Model: PRIPORT Cats-eye		Date: 20-Apr-07	No: M-C269-001
Modified Article: Options change for Cat's-eye		Prepared by: K. Yamamoto	
From: Priport Service Planning Section			
Classification:	☒ Parts catalog correction ☐ Vendor change ☐ To meet standards ☐ To facilitate assembly ☒ To improve reliability () ☐ Part standardization ☐ Other ()		
Model Name: Cat's-eye: Ricoh DX4640PD, Gestetner CP6340D, Savin 3585DNP2, Standard SD462, Lanier LDD350d

Change/Reason: The parts below were added or changed to support use with the Cat's Eye.

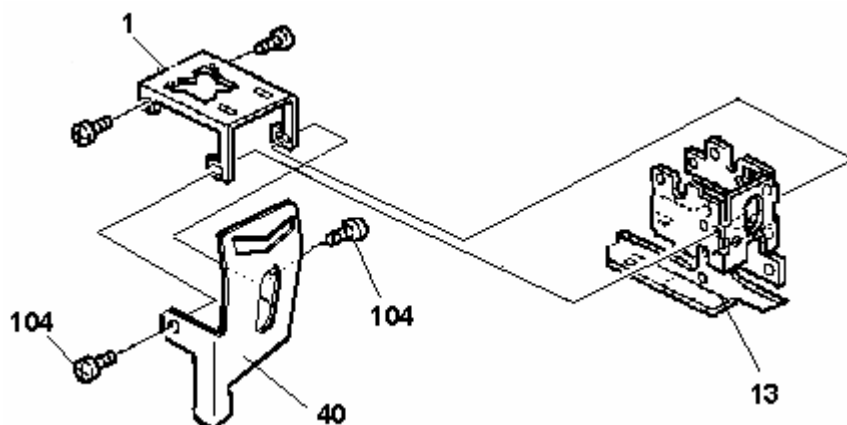
2. PostScript 3 Module

The part number and version number of the firmware were changed.

Important: Update the firmware to this version if you install a PS3 module produced before Dec 2006 on the Cat's Eye.

Exit pump spring

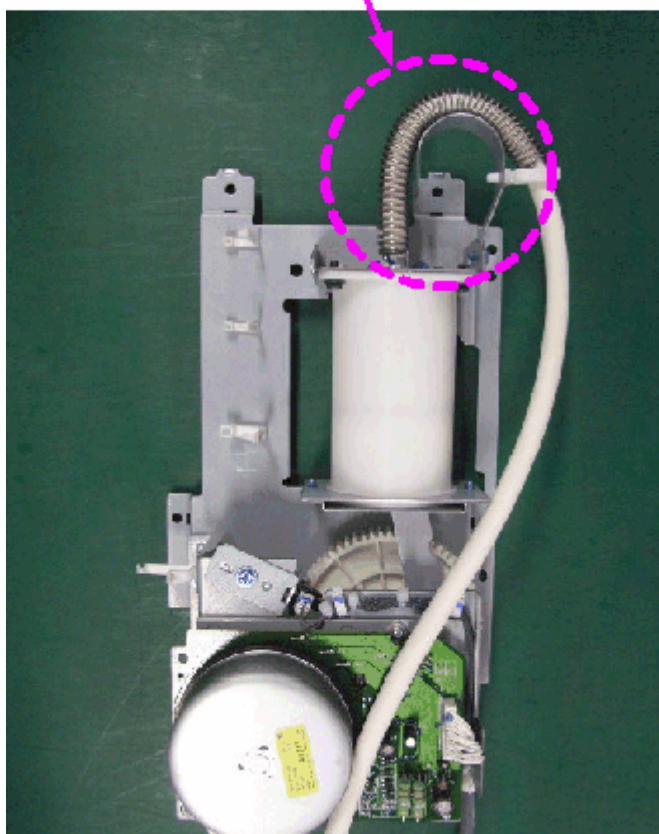
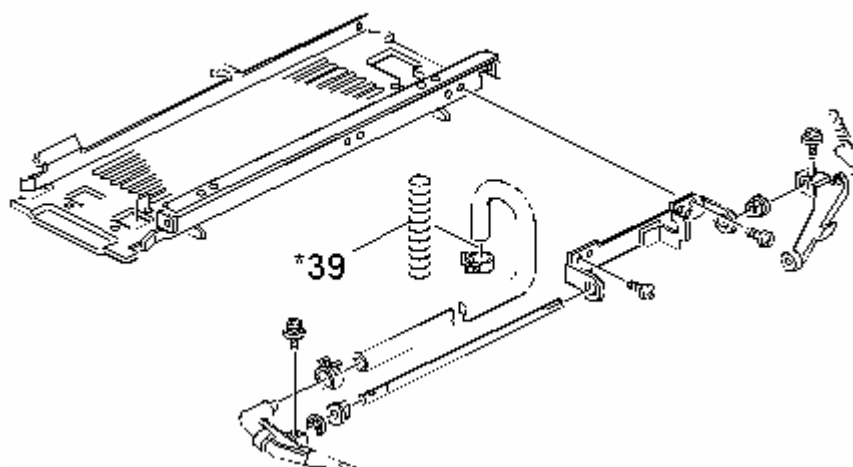
Change: The spring is added to the hose of the exit pump unit.

Reason: To ensure that the hose is not bent too sharply (since this can block the airflow).

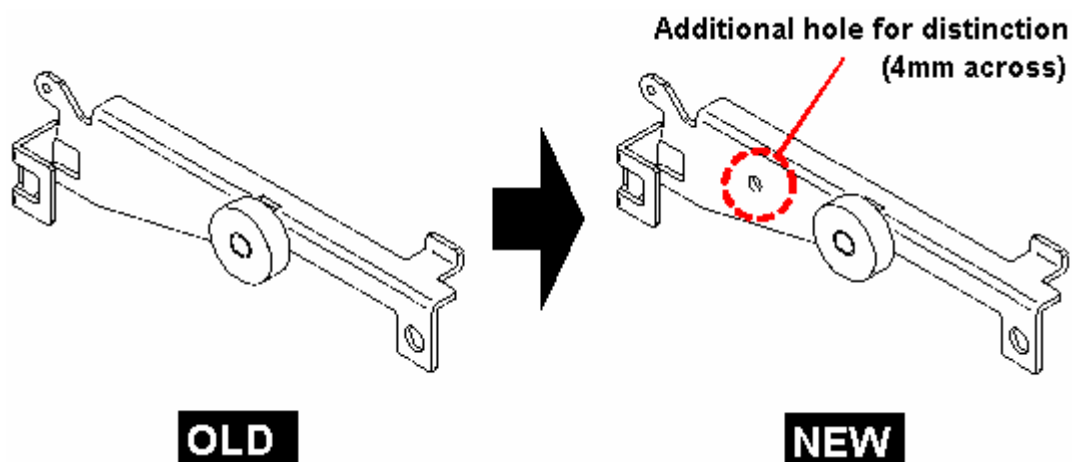
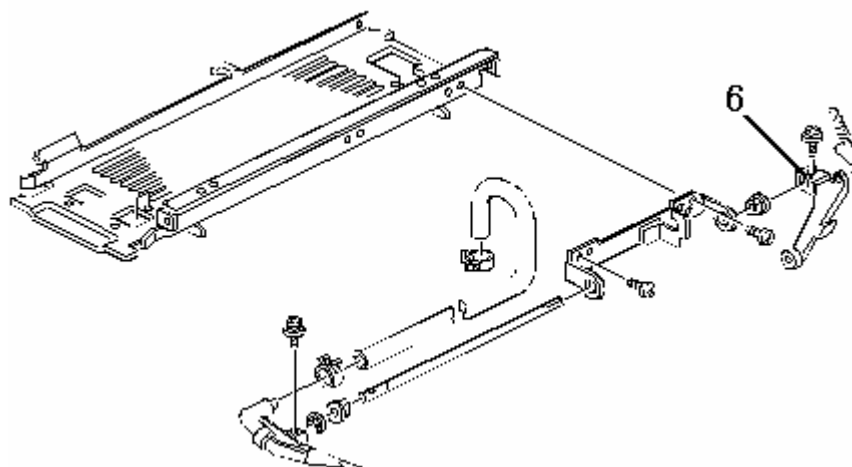
Change: The shape of the exit pawl arm was changed, and a hole was added as shown.

Reason: To ensure that the exit pawl does not touch the leading edge of the master.

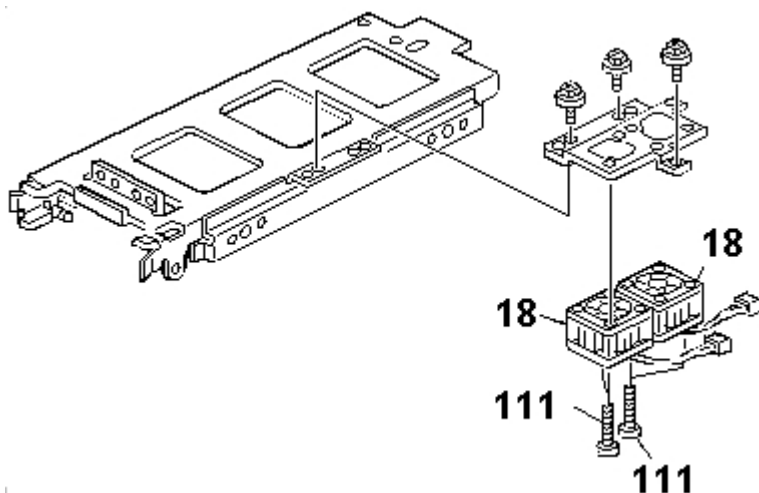
- 1) The force of the master buffer fan airflow was increased (doubled).
- 2) The length of the screws was changed.

Reason: To improve the performance of the master feed mechanism in the master duct unit.

Important: Install the motor and screws together as a set.

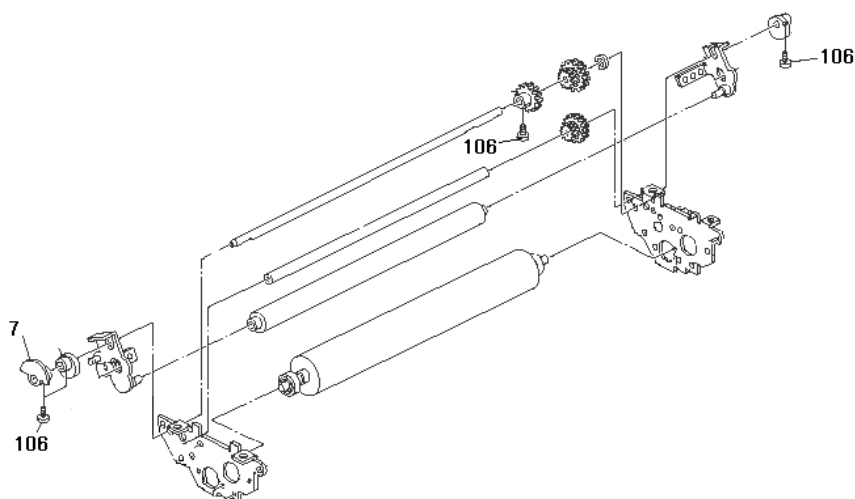
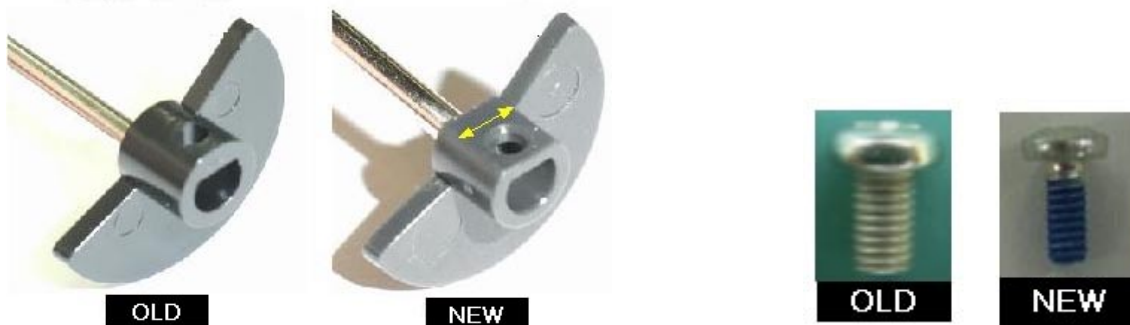
Change: The shapes of the sensor actuator and drum screw were changed.

Reason: To further ensure the screw stays in place.

Note: If the screw comes loose, SC315 (idling roller motor lock) may occur.

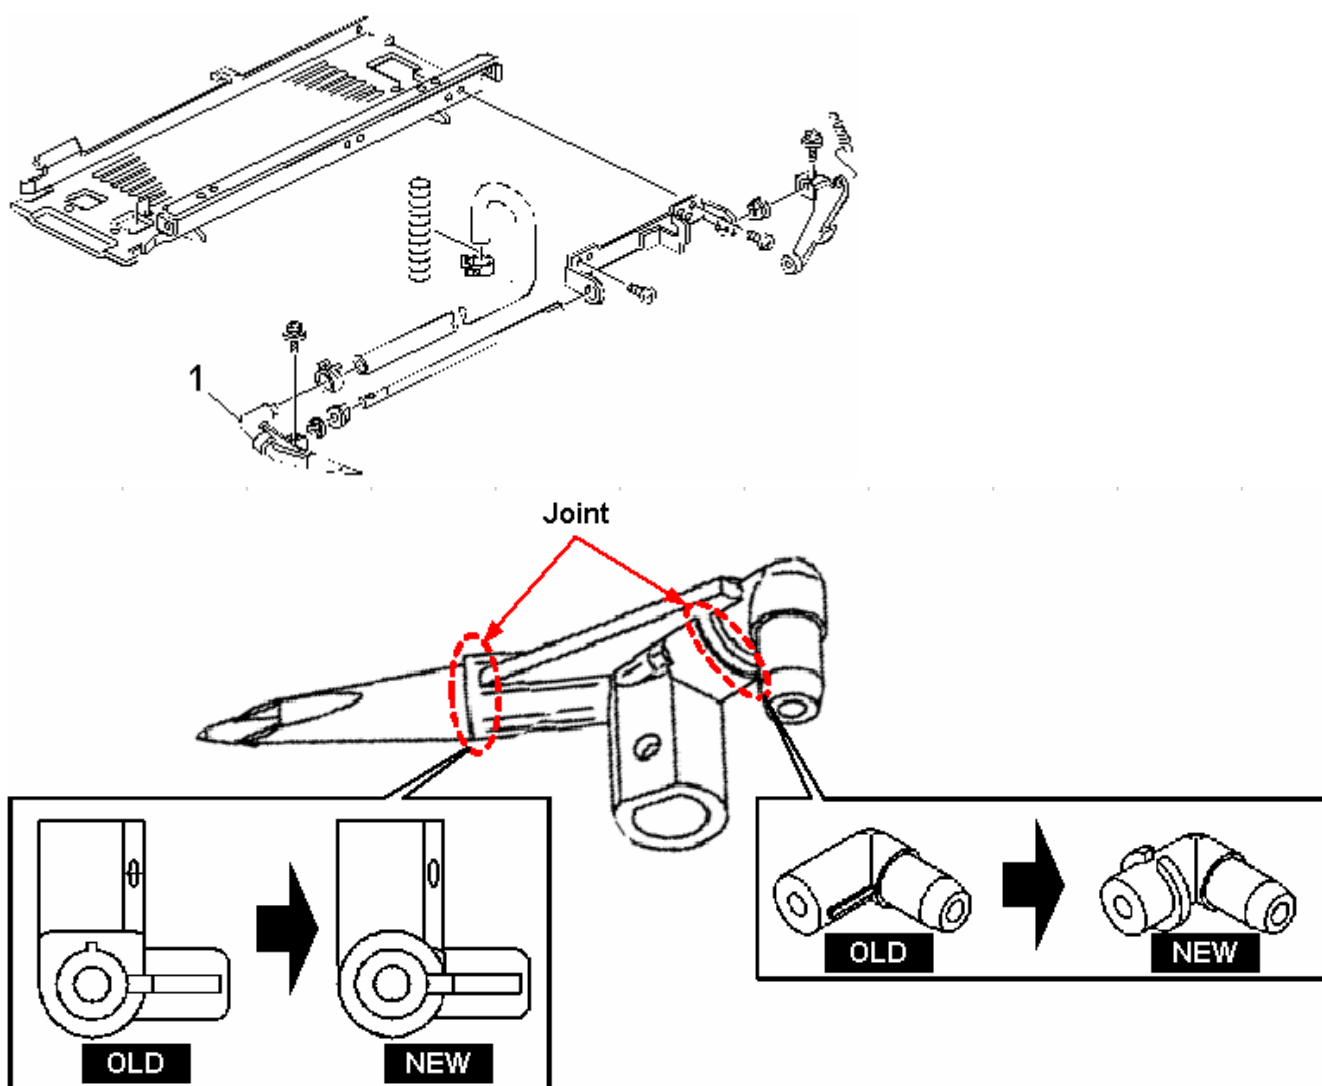
Change: The shape of the paper exit pawl joint was changed.

Reason: To ensure that a paper upper-wrapping jam does not occur (which can cause an air leak).

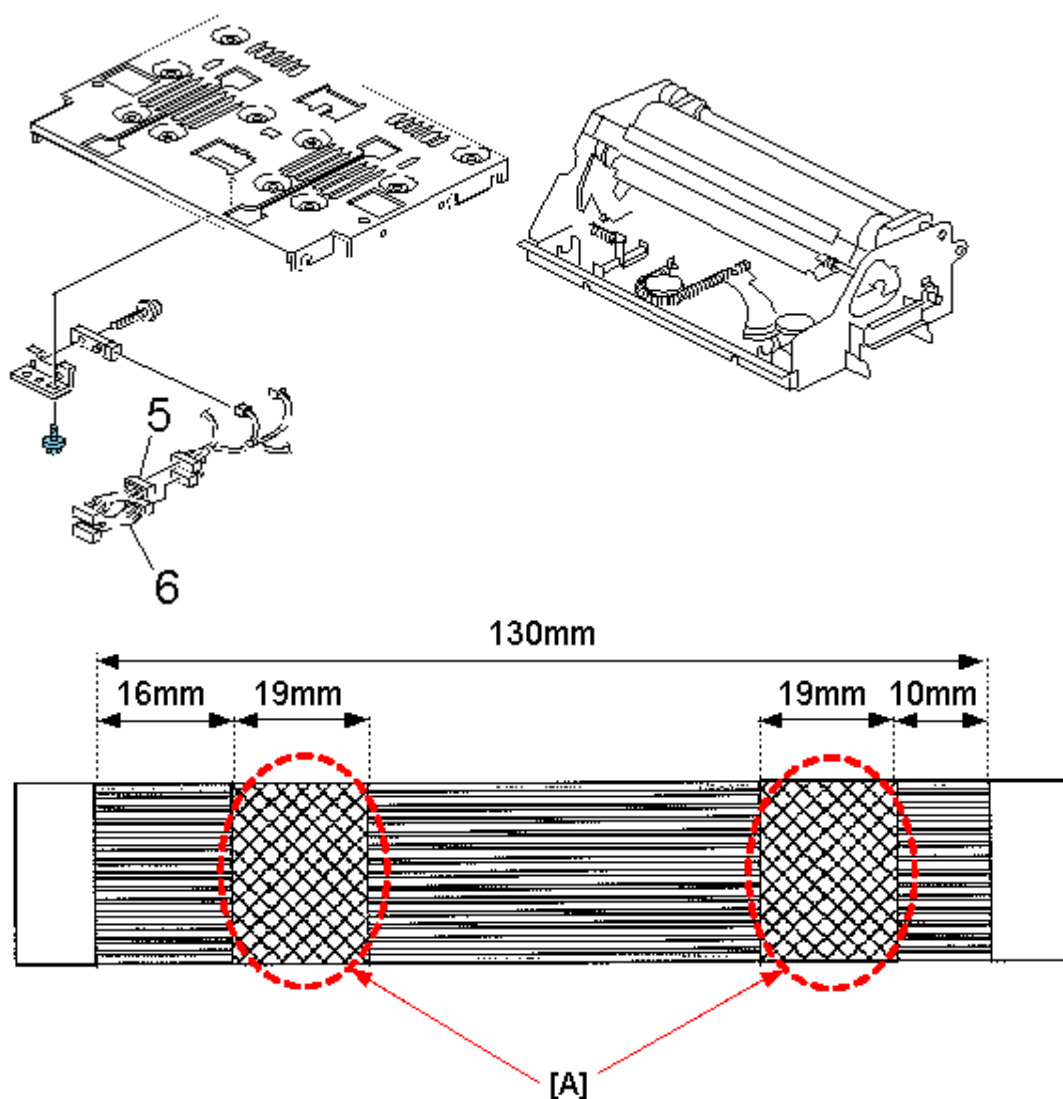
Change: Protective tape [A] was added to the harness and flat cable of the duplex unit.

Reason: To further improve the durability of the harnesses.

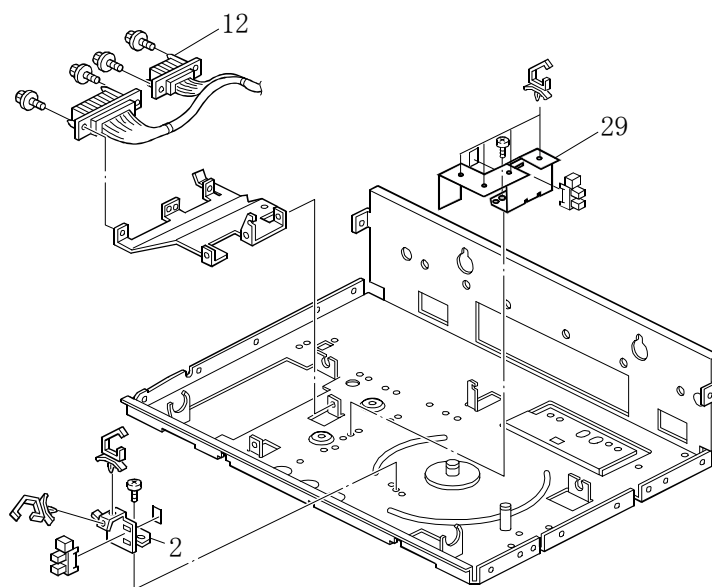
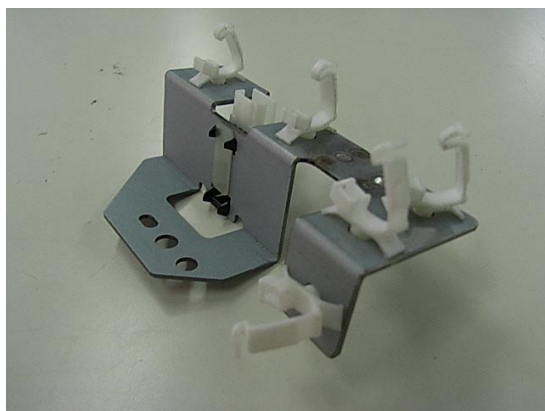
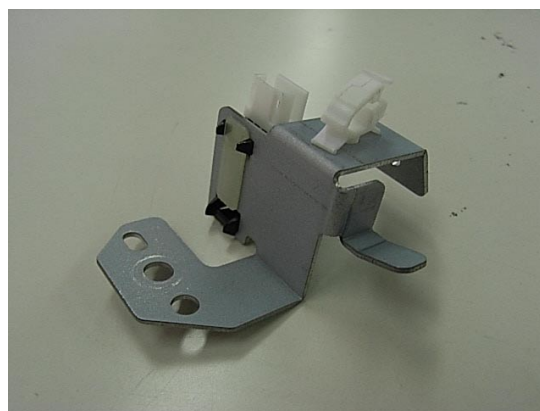
Change: The layout of the harness is changed.

Reason: The edge of the duplex unit suction fan hits the harness and damages it.

Note: Replace the harness [12] and sensor bracket [29] **together as a set**

New Bracket (C2694822)

Old Bracket (C2694775)

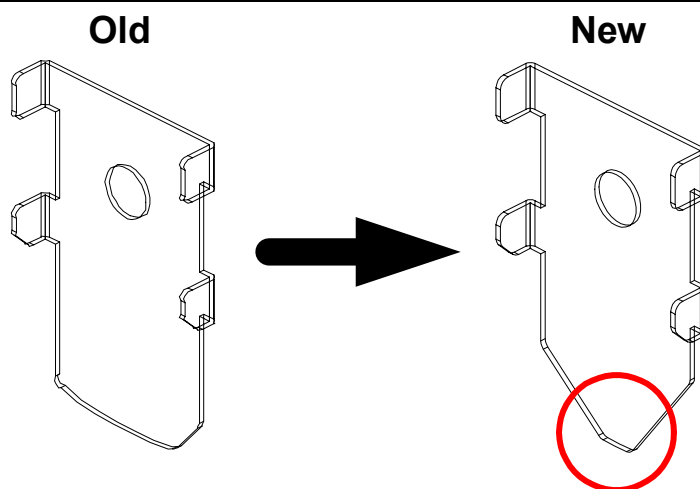
B-jam or BZ-jam occurs (paper does not reach the duplex unit).

The tip of the duplex clamper is worn out, and the paper slips away from the duplex clamper.

Note: The shape of the area shown was changed, so that the clamper can grip the paper more securely.

Replace the duplex clamper.

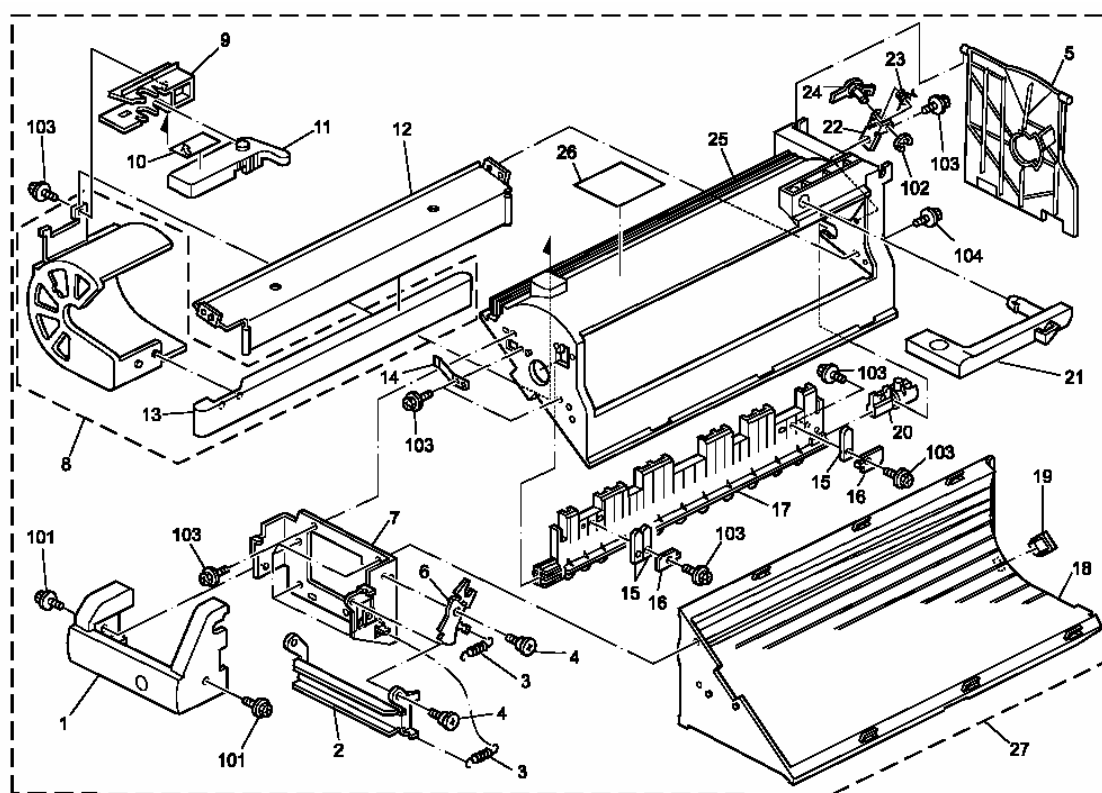
Change: The shapes of the component parts of the Master Eject Box were changed (the measurement specifications were made stricter).

Reason: To ensure that the parts do not bump each other when ejected masters are ejected from the master eject box.

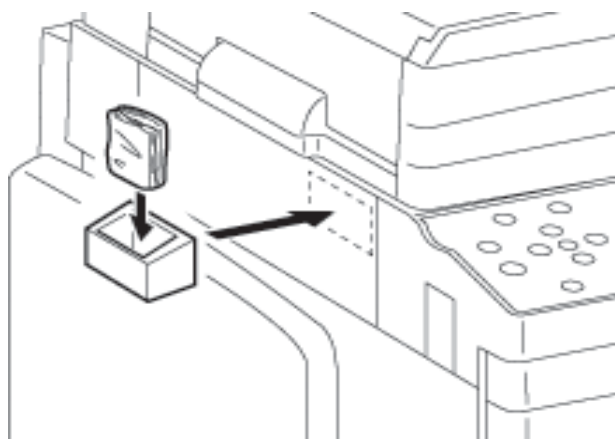
Change/Reason: The parts in the table were added as service parts (they are already contained in the Accessories Bag).

Important: Attach the cloth holder at machine installation.

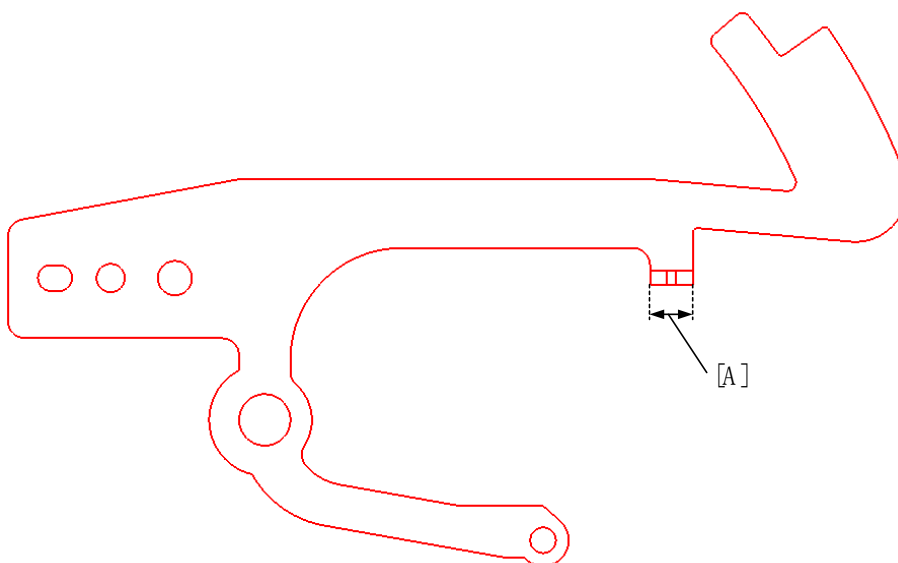
Change: The width [A] at the feeler of the paper height sensor was decreased, from 7.0mm to 5.0mm.

Reason: SC521 (Paper table lock, paper table height sensor) occurs when the feeler gets caught and prevents the feeler from lowering (the paper table height sensor cannot de-actuate).

[A]: 7.0mm => 5.0

21.Duplex Unit 5 (C269)

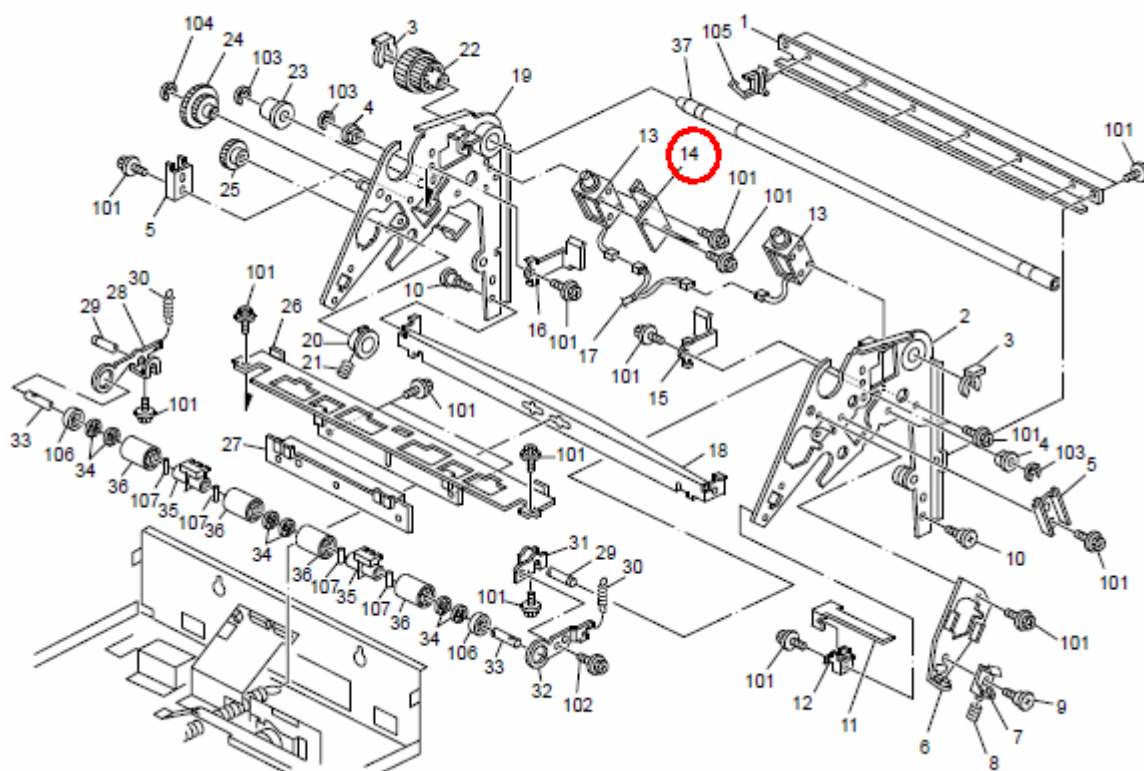
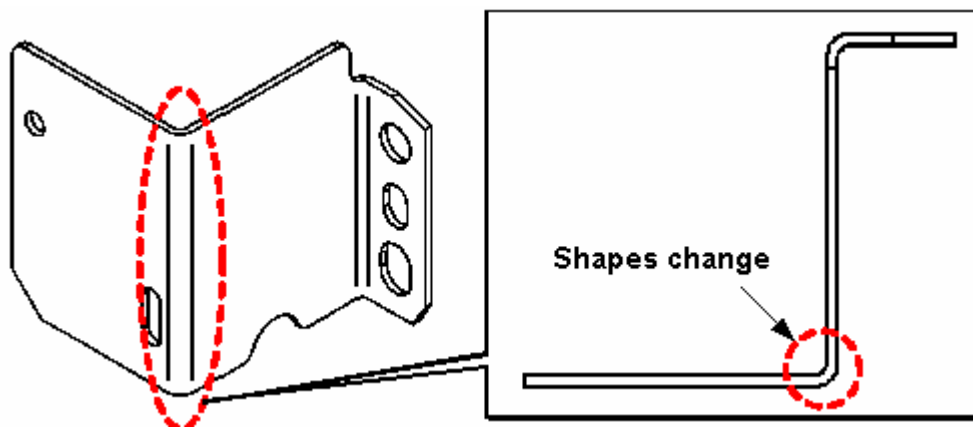
Change: The shapes of these parts were changed

Reason: To improve the durability of these parts.
